TECHNICAL COMMITTEE RECOMMENDATION

TECHNICAL COMMITTEE: Bicycle Technical Committee

TOPIC: Proposed M1-8a Bicycle Route Sign,
Sign Size Options for M1-8, M1-8a, M1-9 -
Part 9 of the MUTCD

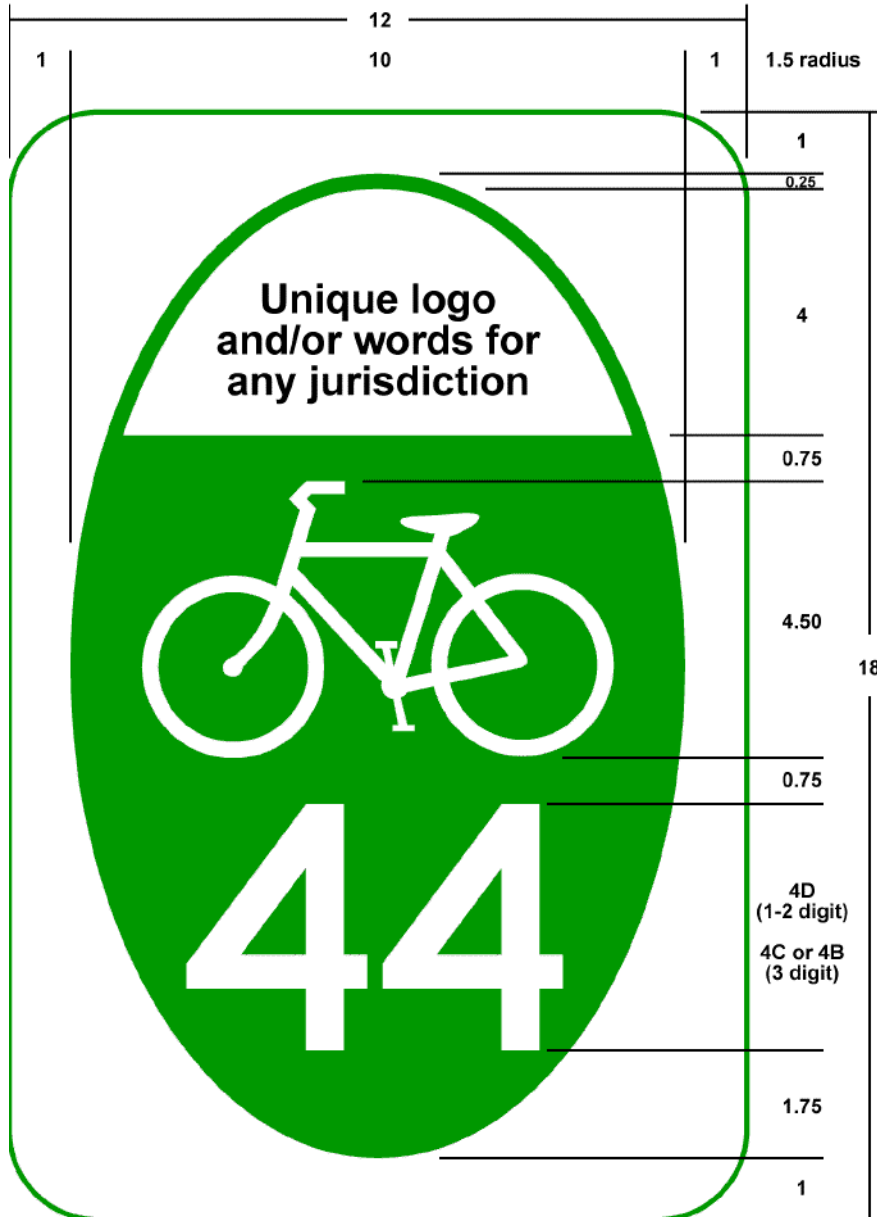
The 12" x 18" M1-8 Bicycle Route sign has been in the MUTCD since 1978, and has been used successfully by many agencies to establish route guidance for bicyclists in much the same way that other M1 series numbered route signs are used to guide other road users.

There has been a significant amount of interest in allowing agencies to develop unique or distinctive route number signs for bicycle routes, in much the same way that states use distinctive M1-5 signs for state highways. However, this could lead to route sign designs that are unclear and non-uniform. The proposed M1-8a sign retains the clear, simple, and uniform design of the M1-8, but adds a region near the top of the panel for an agency to place a unique logo, symbol, or words to identify the jurisdiction having authority over the route. The M1-8 sign will continue to remain in the MUTCD for use when agencies do not wish to use a distinctive logo, symbol, or wording.

Examples of M1-8a Signs

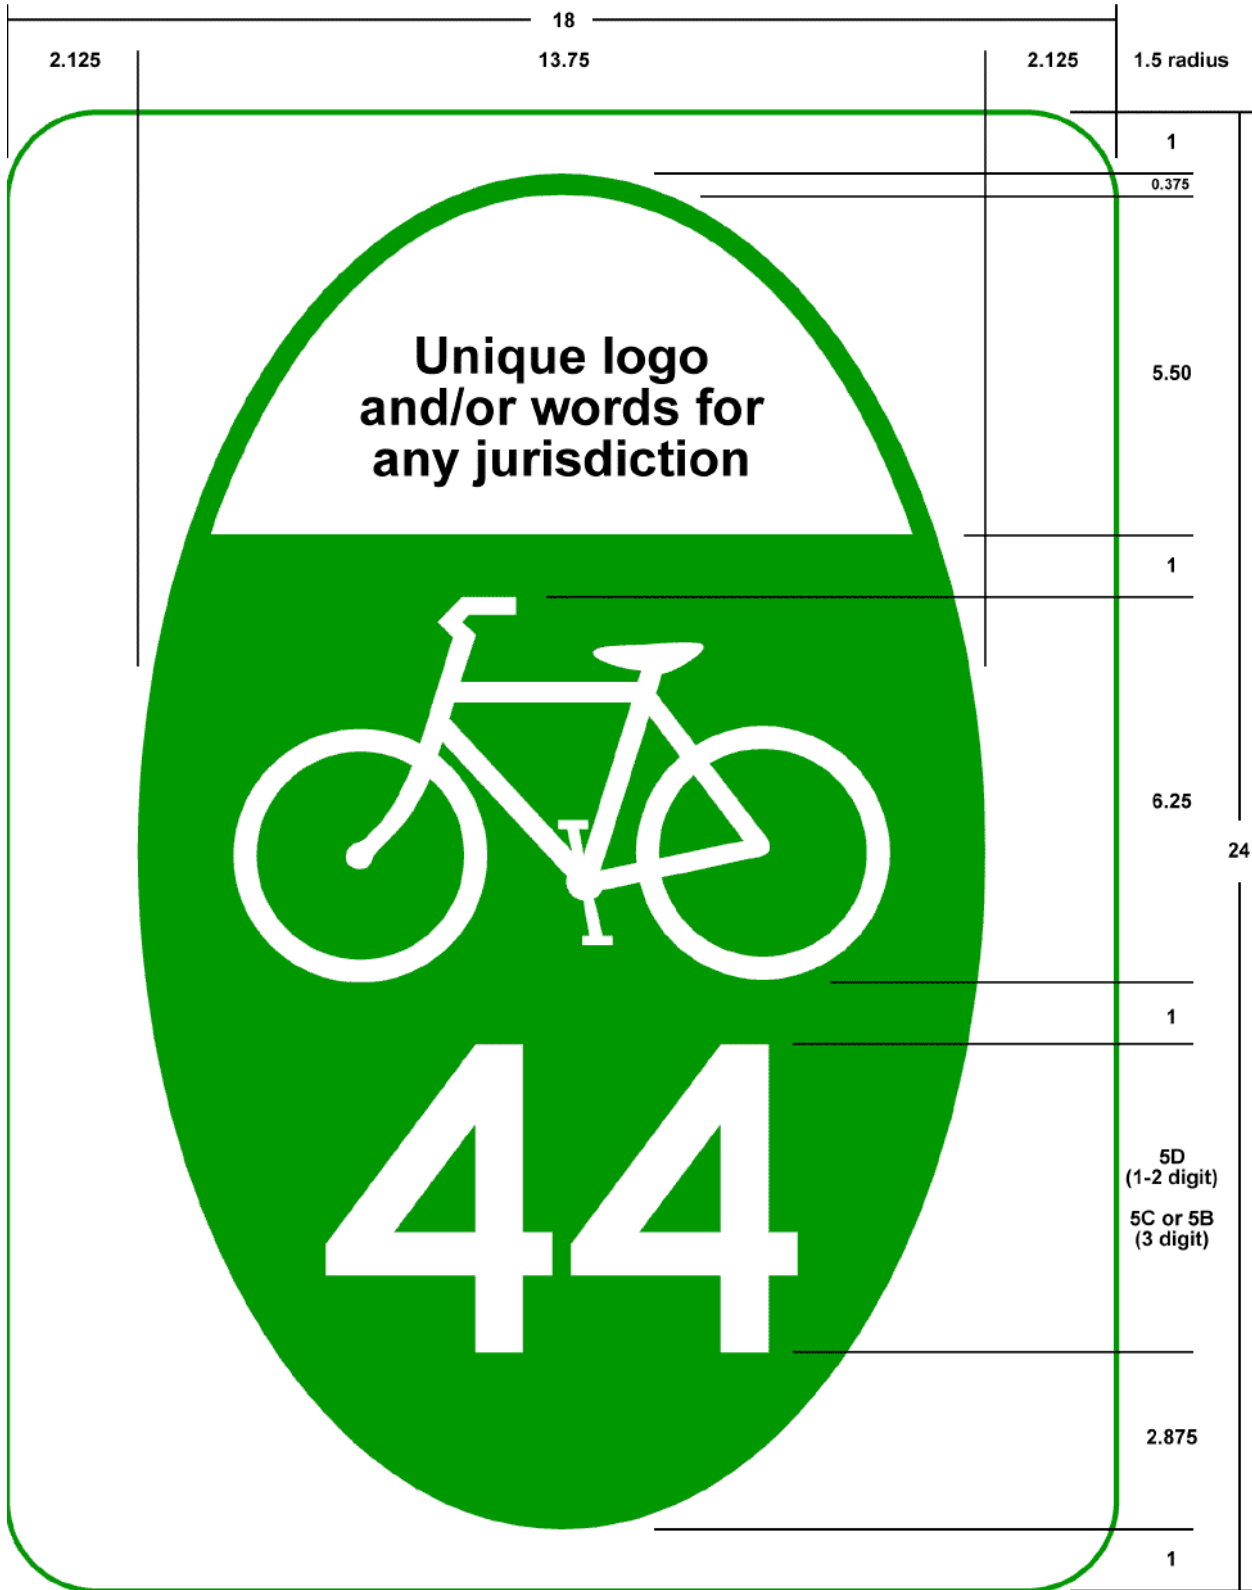
Currently, only one 12" x 18" size is defined in the MUTCD for the M1-8 sign, and only one 18" x 24" size is defined for the M1-9 US Bicycle Route sign. The 12" x 18" sign size can be quite appropriate for shared-use paths and low-volume rural roadways. Conversely, an 18" x 24" sign size is easier for bicyclists to detect in locations such as busy urban streets. To cover both situations, the NCUTCD Bicycle Technical Committee recommends that the M1-8, M1-8a, and M1-9 signs all be listed in the MUTCD in a standard 18" x 24" size for streets and highways, with an option to use a smaller 12" x 18" size for use on pathways and low-volume rural roadways.
